Addendum NO 1

DATE: May 5, 2021

FOR: **Dallas County BRO-B030(10)**

ROCKSDALE RD BRIDGE #23800001
DALLAS COUNTY, MISSOURI
BRIDGE PLAN & ELEVATION

DETAILS OF INTERMEDIATE BENT NO. 2

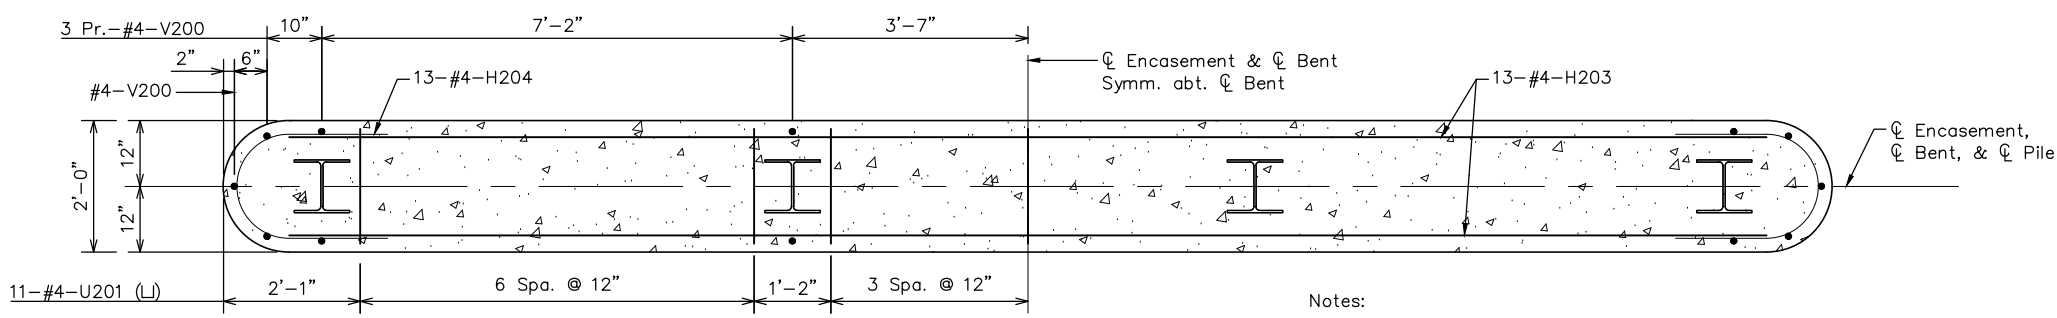
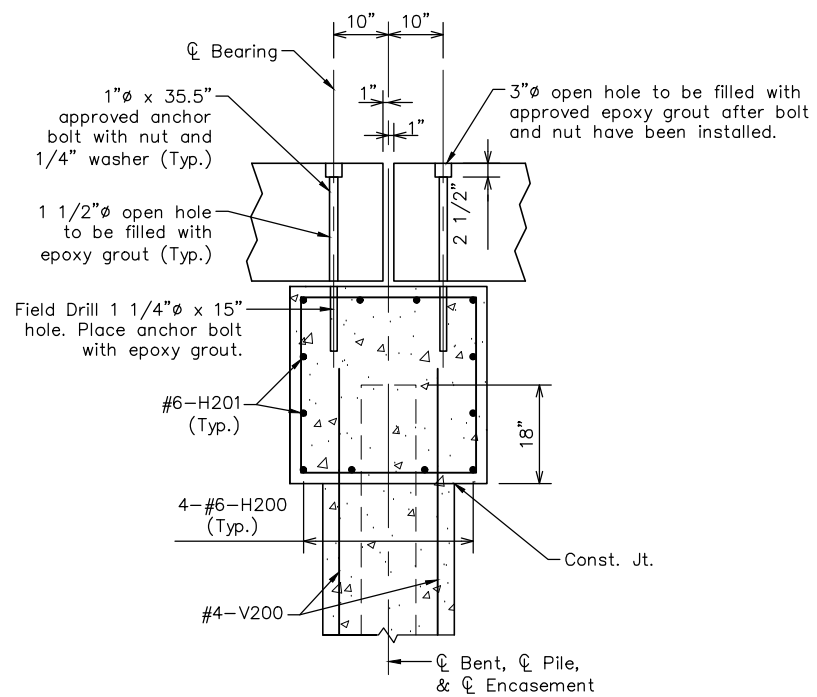
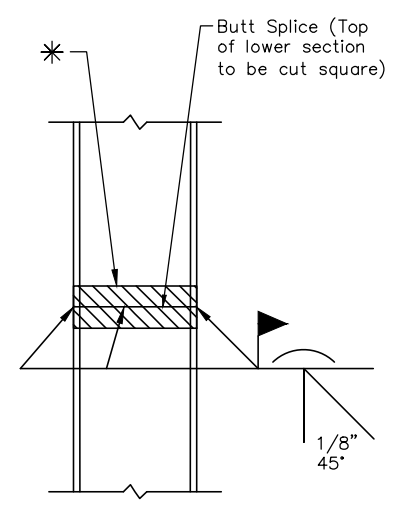
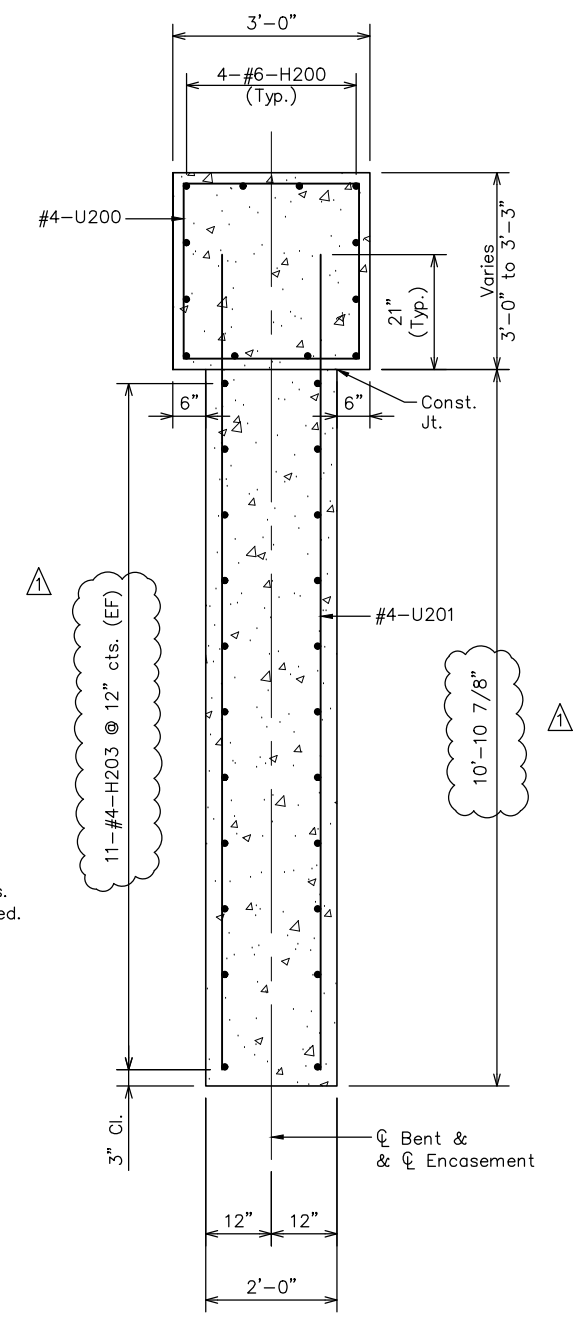
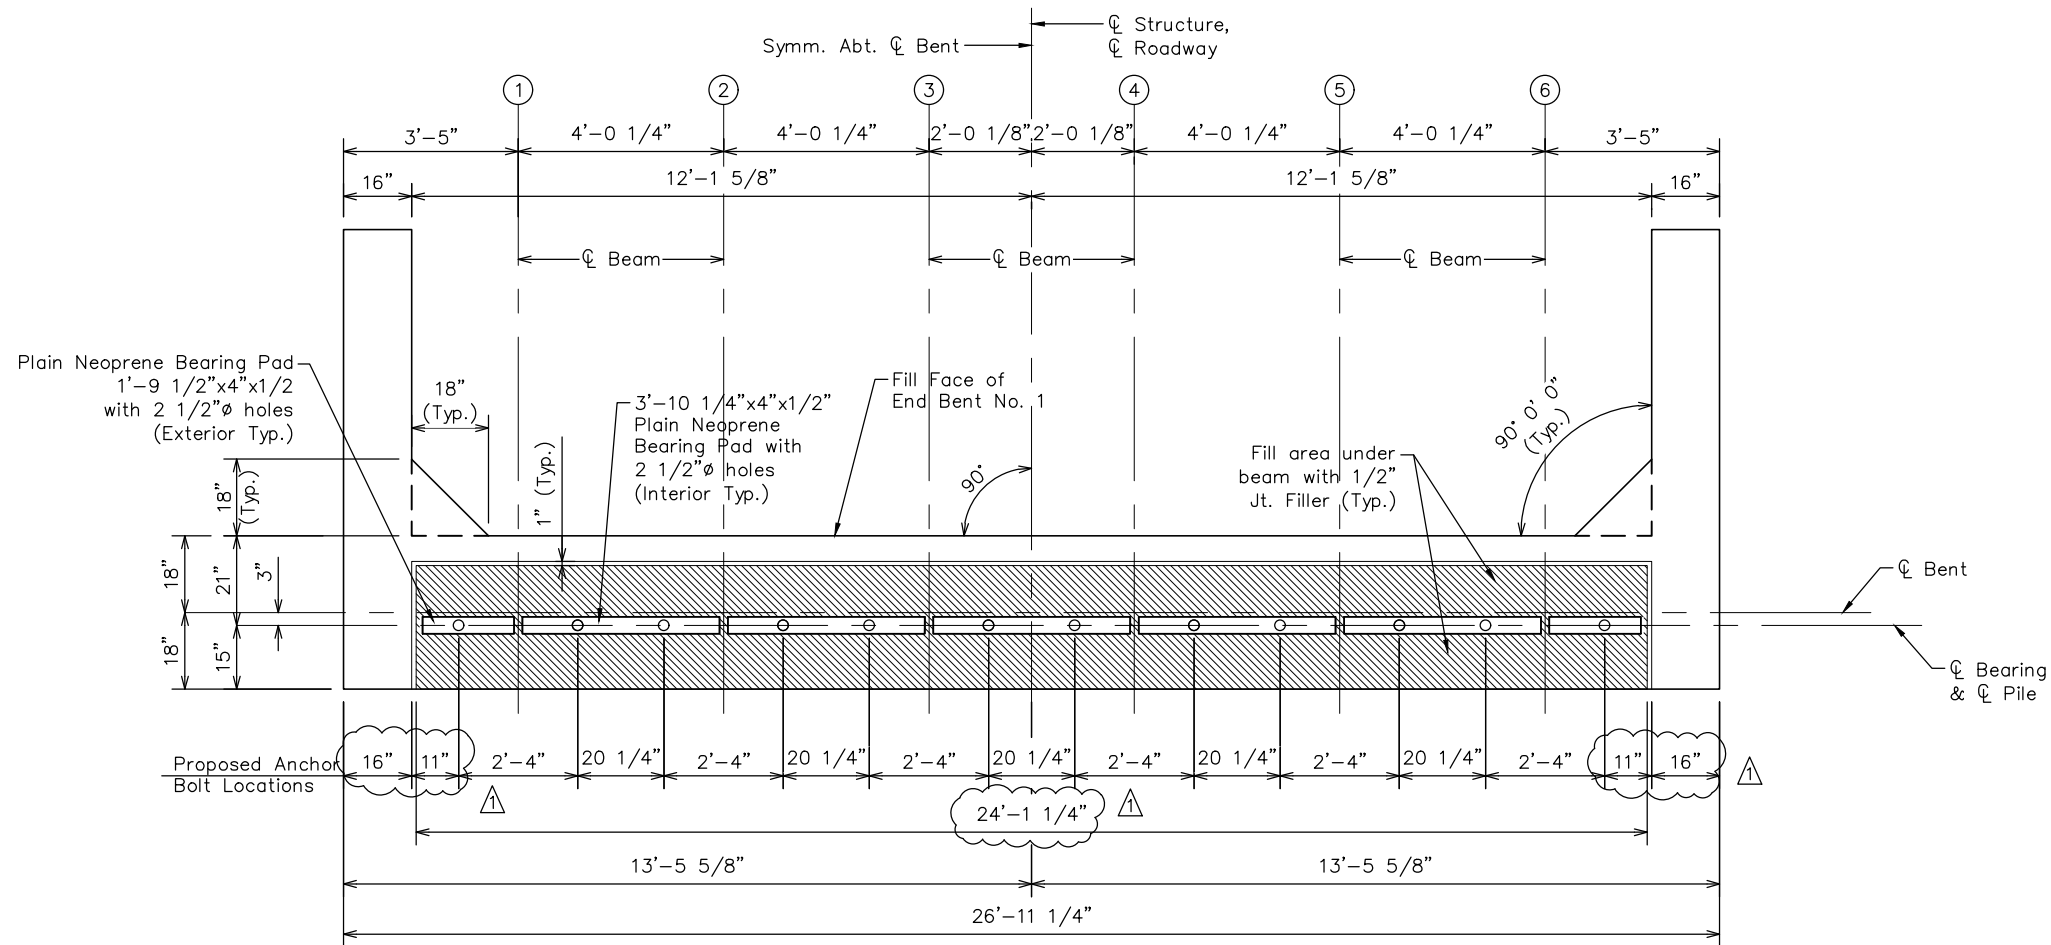
Sheet S7- The dimension for the height of the Encasement has been updated. The quantity of the H203 and H204 bars has been updated. The Class B-1 Concrete and Reinforcing Steel quantities have been updated under the Substructure Quantity Table for Bent No. 2.

DETAILS OF END BENT NO. 3

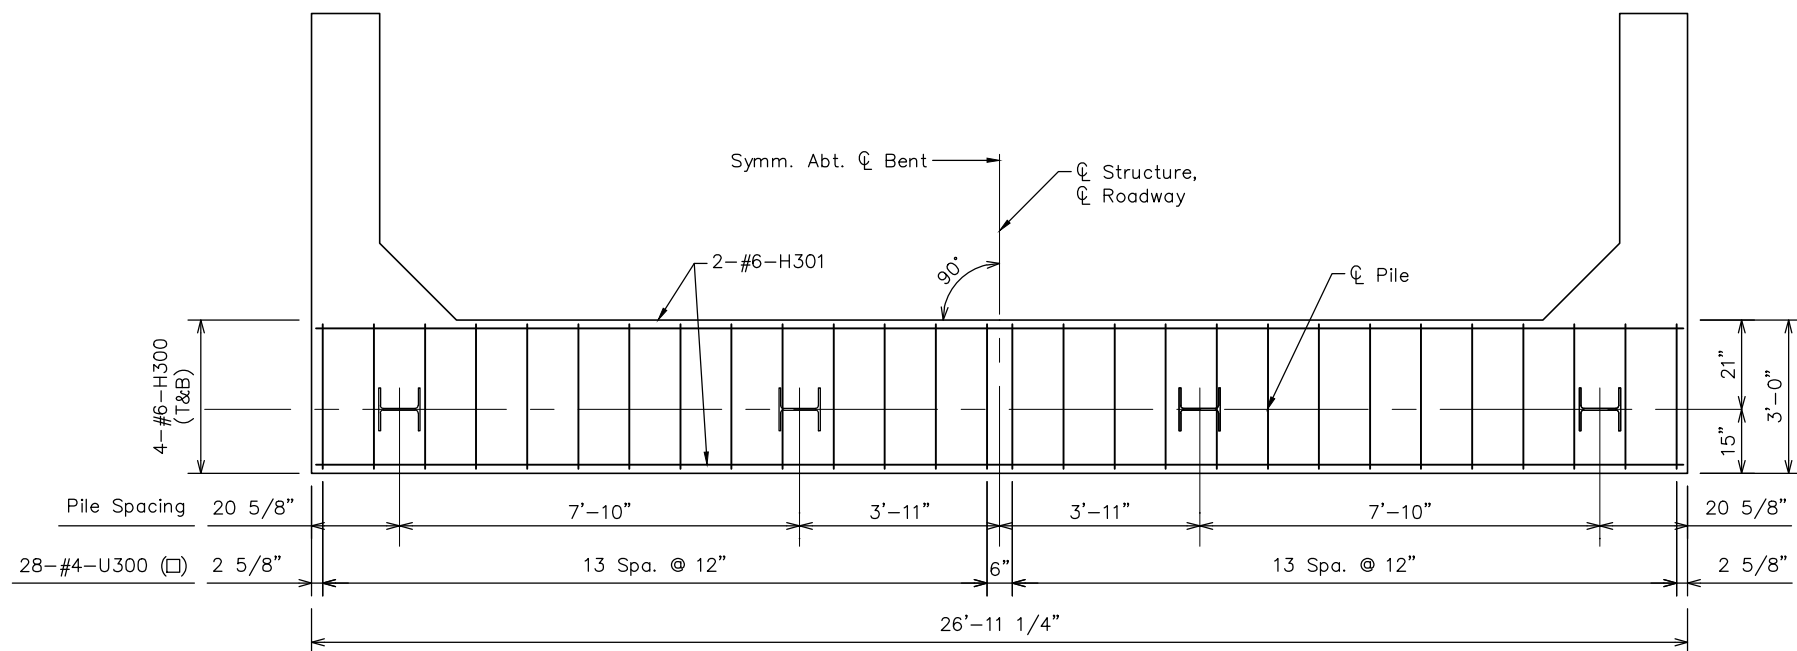
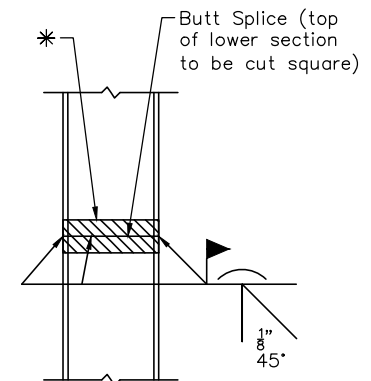
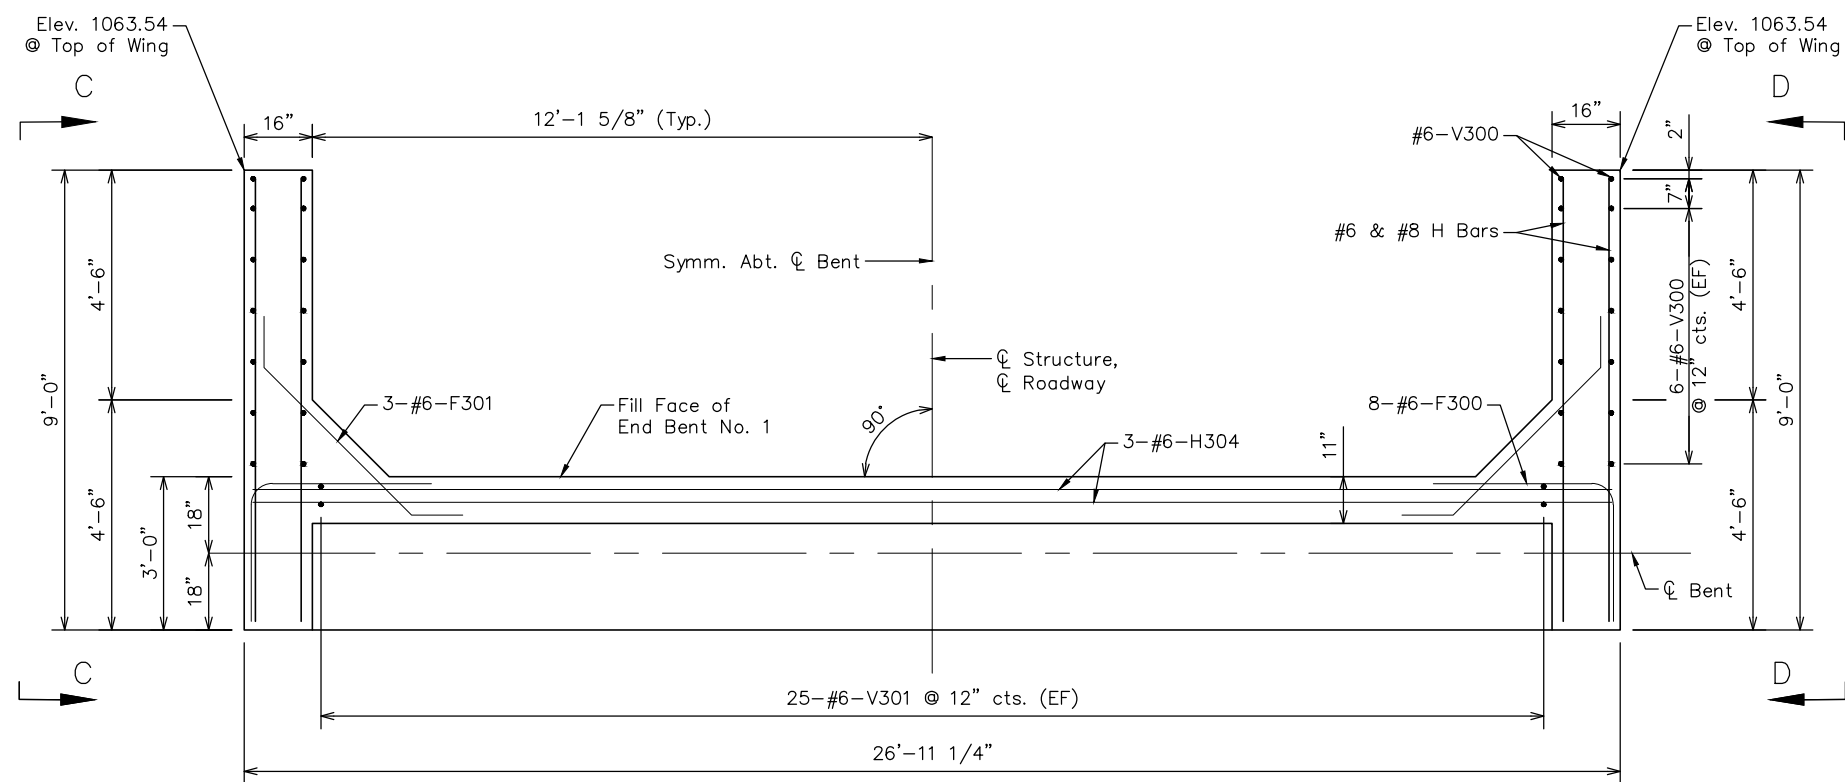
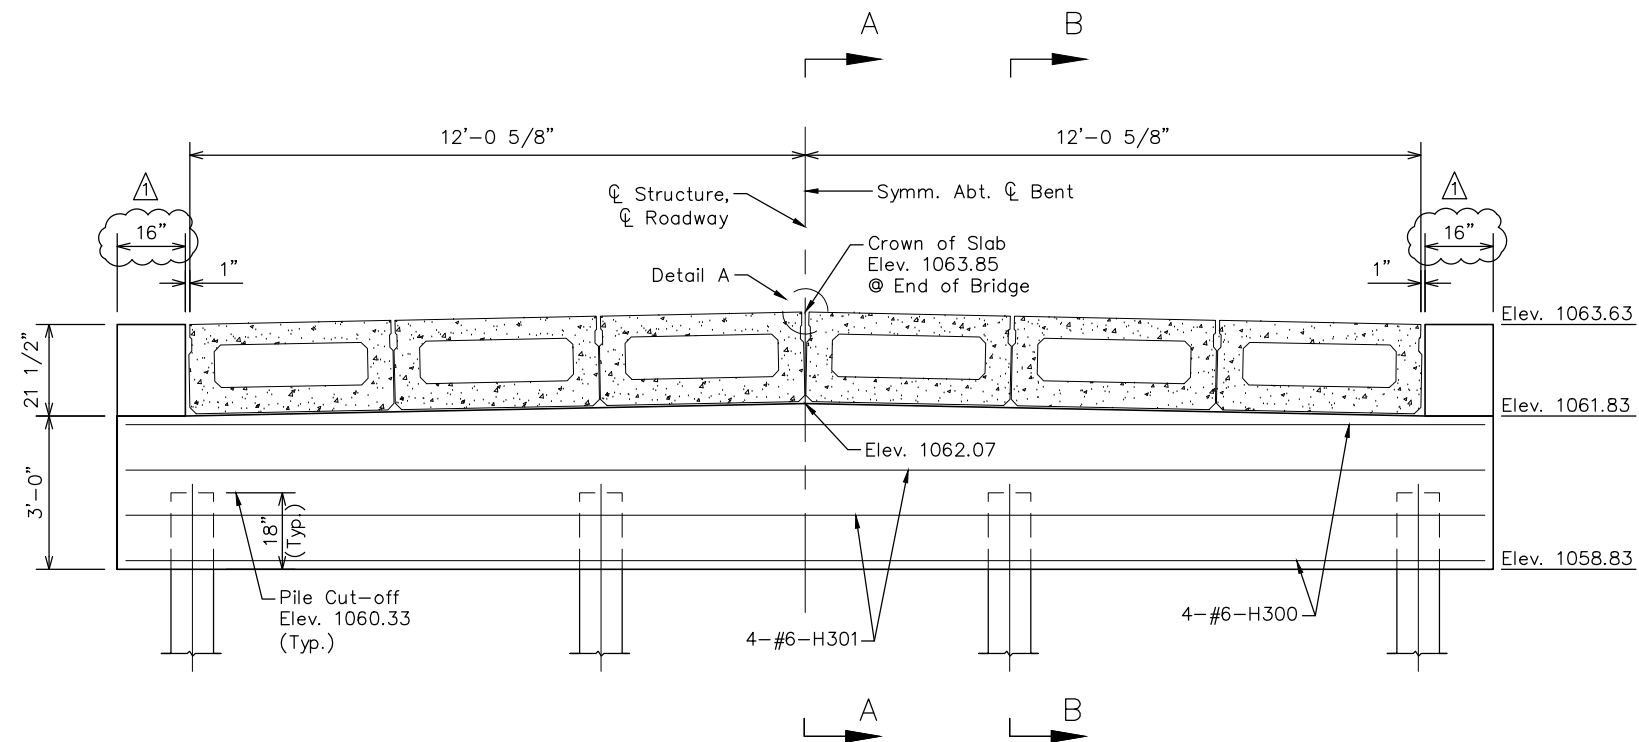
Sheet S8- End bent dimensions have been updated.

DETAILS OF END BENT NO. 3

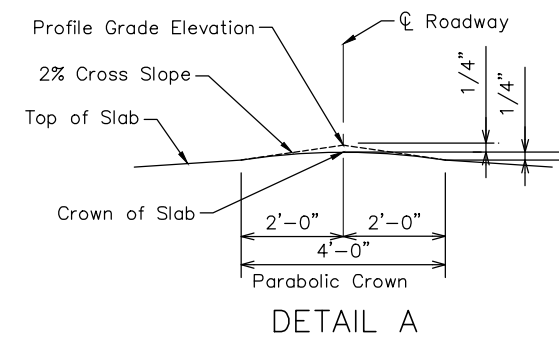
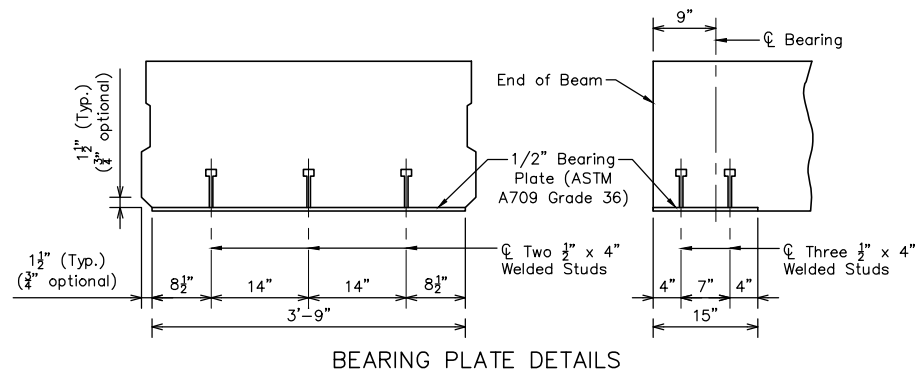
Sheet S9- End bent dimensions have been updated.

BOX BEAM DETAILS

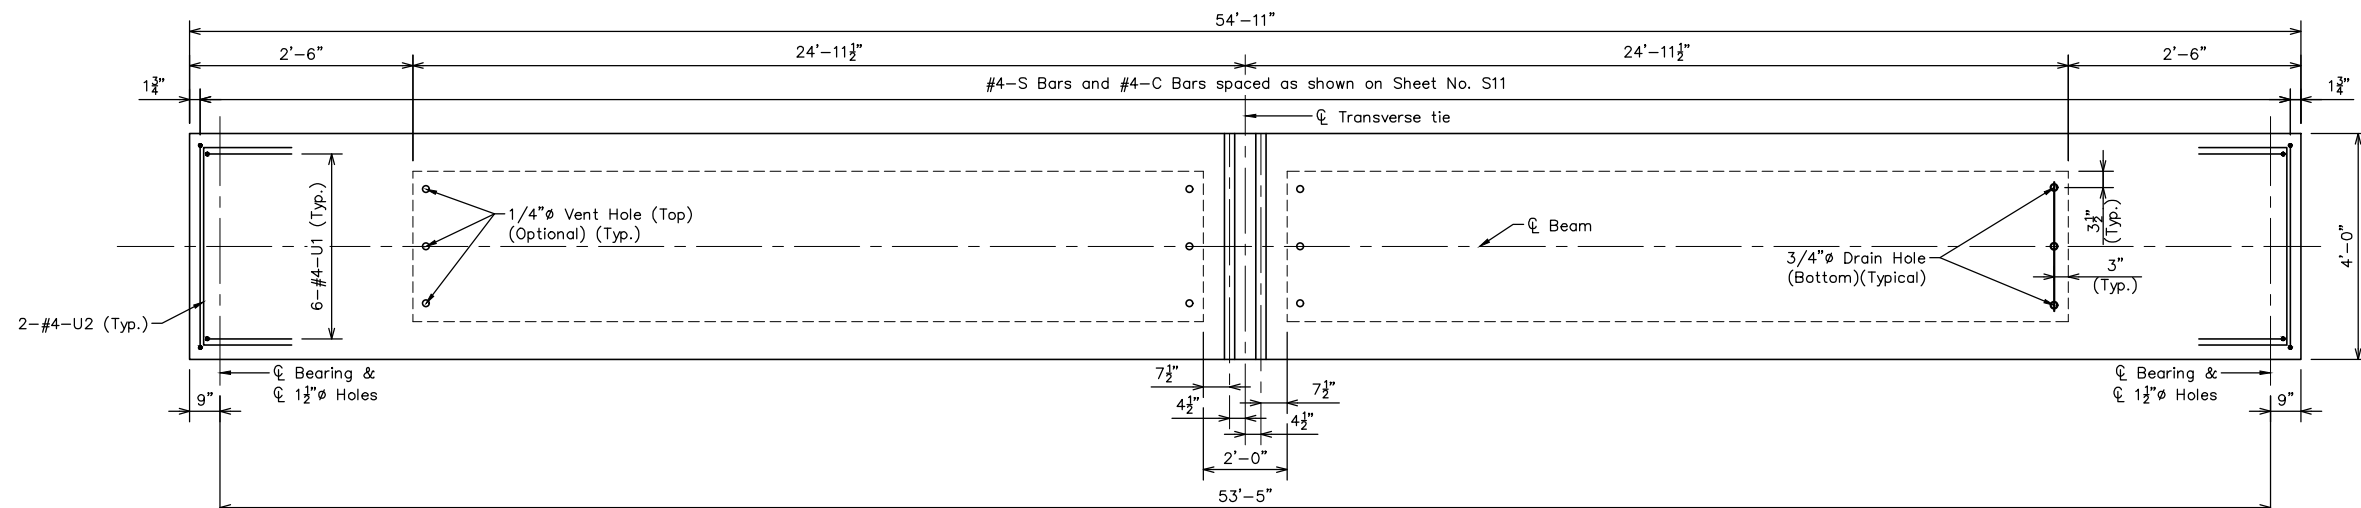
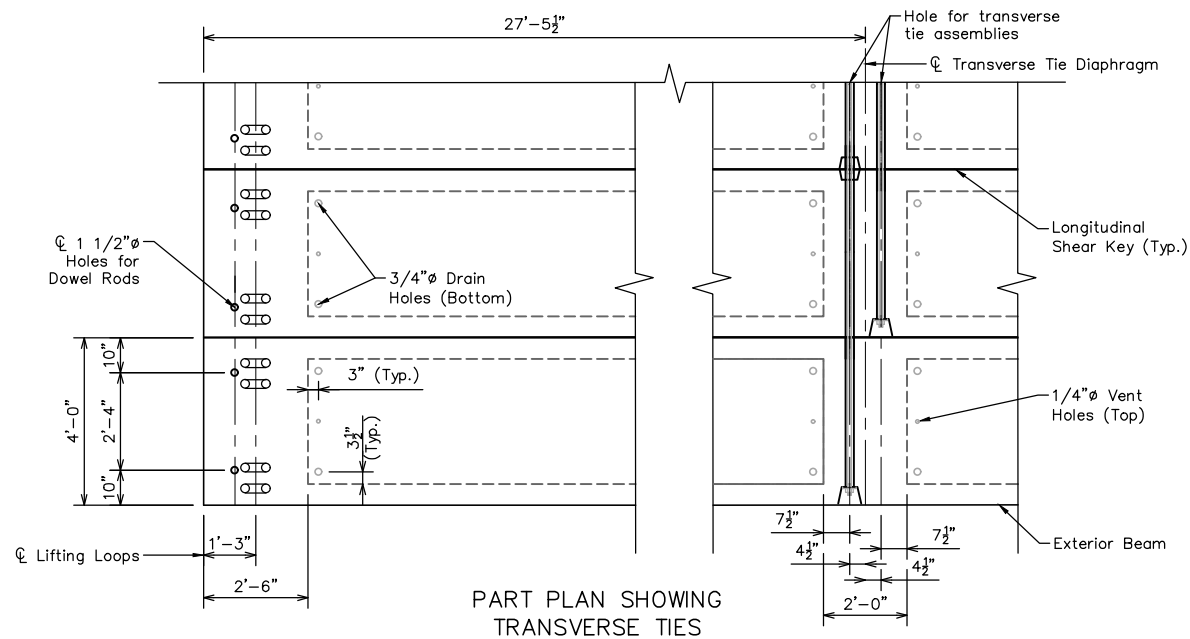
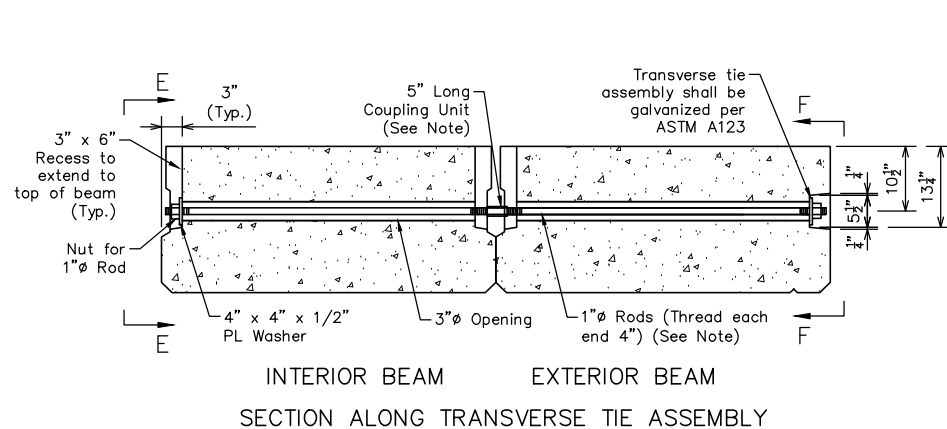
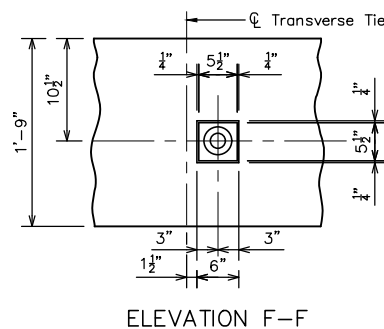
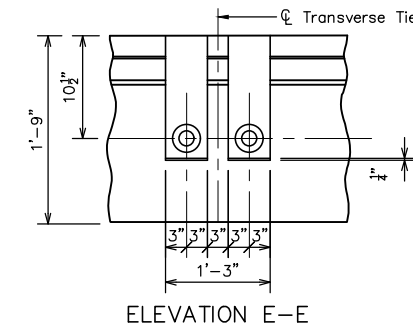
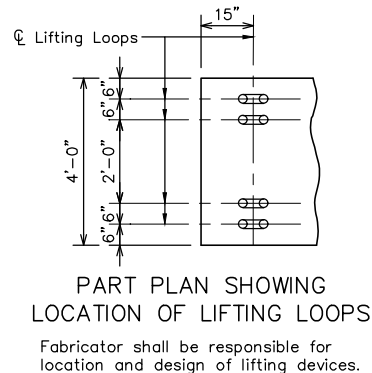
Sheet S12- References to epoxy grout have been removed and replaced with non-shrink grout.

The 1" diameter rods in the transverse tie assembly shall be tightened to a snug fit and then pre-tensioned by turn-of-nut pre-tensioning method. 1/3 turn must be applied after a snug fit has been applied. Pockets that receive transverse tie bar outside shall be filled with non-shrink grout after transverse tie assembly is in place. Tie rods shall be ASTM A36.

Longitudinal shear keys shall be non-shrink grouted.
